# PLANNING AND ZONING CASE CHECKLIST

City of Rockwall  
Planning and Zoning Department  
385 S. Goliad Street  
Rockwall, Texas 75087

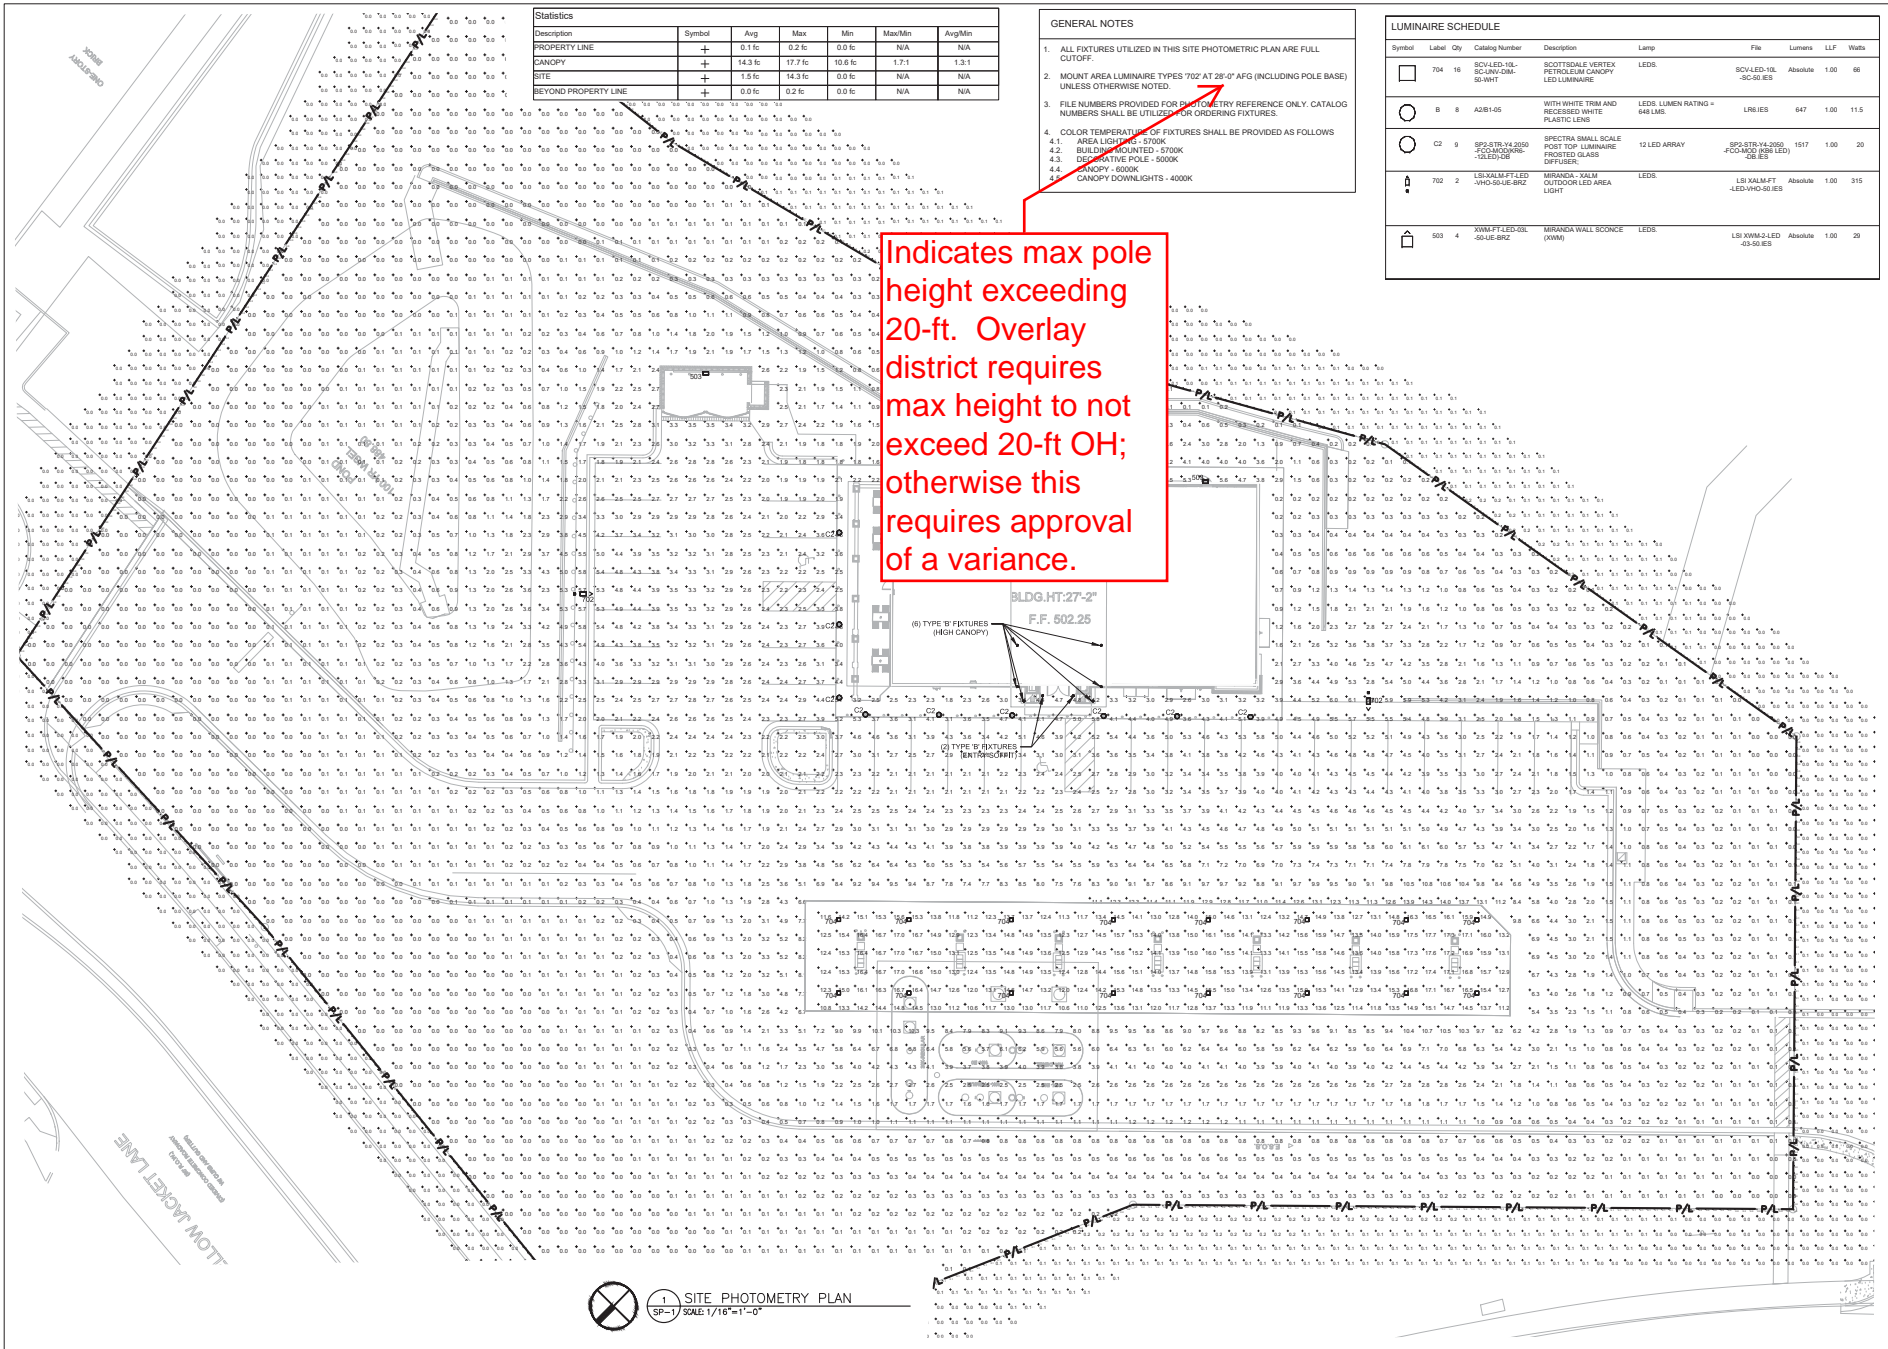
Type of Review / Notes	Contact	Sent	Due	Received	Elapsed Status	Remarks
PLANNING	David Gonzales	9/21/2018	9/28/2018	9/21/2018	COMMENTS	See comments
<p>* Planning Department General Comments:</p> <ol style="list-style-type: none"> <li>1. Adherence to Engineering and Fire Department standards shall be required.</li> <li>2. Submittal and approval of a Civil Engineering Plans and Final Plat prior to issuance of building permits. As a note, plat mylars must be received for filing purposes prior to release of any building permits.</li> </ol> <p>** Please address the following Planning Comments:</p> <p>Site Plan: Date on plan is 07/20/2018</p> <ol style="list-style-type: none"> <li>1. Remove label "14" under gas canopy, we do not count as parking spaces.</li> <li>2. Site Data Summary Table: change total parking spaces to 32, gas canopy spaces are not considered parking spaces.</li> <li>3. Dumpster enclosure to include a self latching gate mechanism and walls to match exterior materials found on primary structure - add note.</li> </ol> <p>Photometric Plan:</p> <ol style="list-style-type: none"> <li>1. Maximum pole height not to exceed 20-ft overall height (includes pole, pole base, etc.). Provide detail or request variance to SOV district standards (requires 3/4 majority vote).</li> </ol> <p>*** The following are scheduled meeting dates that you and/or your representative(s) are required to attend regarding the Site Plan request. If you have any questions regarding this case, please feel free to contact David Gonzales, AICP with the Planning Department at 972-771-7745 or e-mail <a href="mailto:dgonzales@rockwall.com">dgonzales@rockwall.com</a></p> <p>Scheduled Meeting Dates to Attend:</p> <p>ARB - Action: September 25, 2018 (5:00p.m.) [Provide recommendation to P&amp;Z]</p> <p>Planning - Action: September 25, 2018 (6:00p.m.) [P&amp;Z to take action (i.e. approve, approve with conditions, deny)]</p>
